**REQUEST FOR BID
BID NUMBER 240801**

ADDENDUM NO. 1

Date: February 8, 2024
Re: LOW INCOME COMMUNITY SOLAR
To: ALL PROSPECTIVE BIDDERS

112 IDEA PLACE
CT CABINET

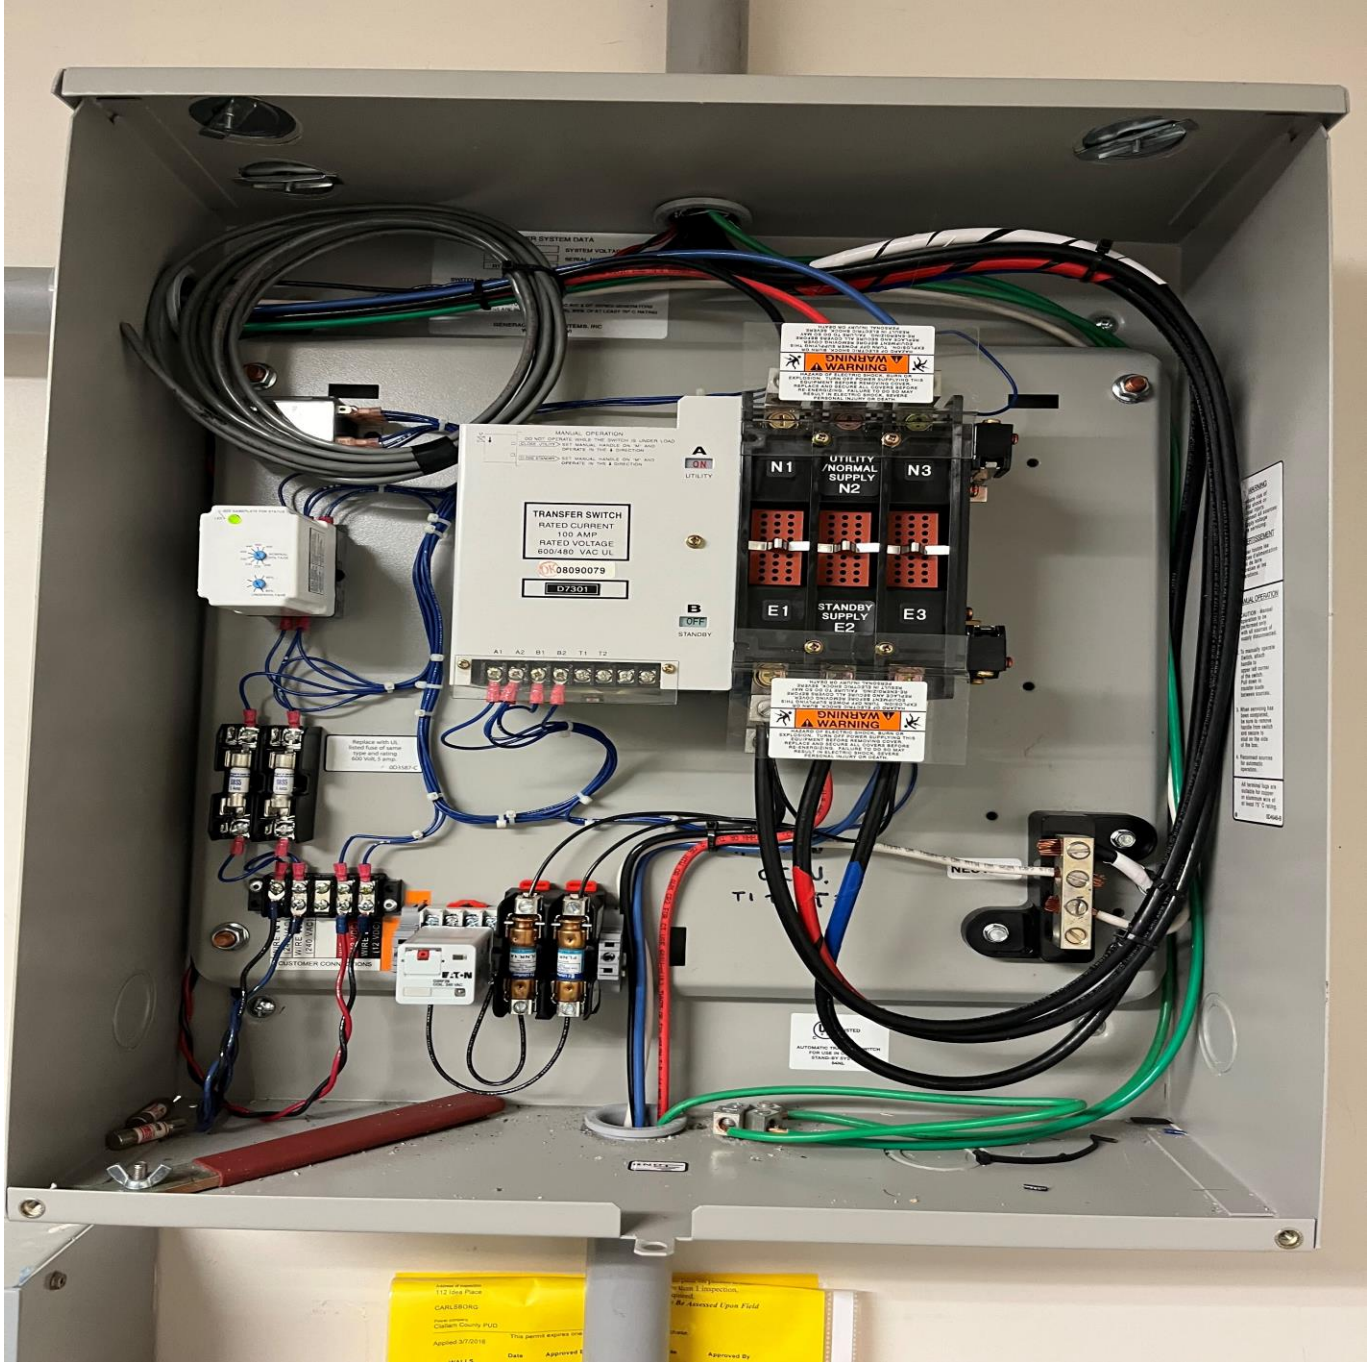
- 1.) Can the District provide pictures of the inside of the CTs cans and the electrical panels for both locations?
 - a. Yes, see added photos below
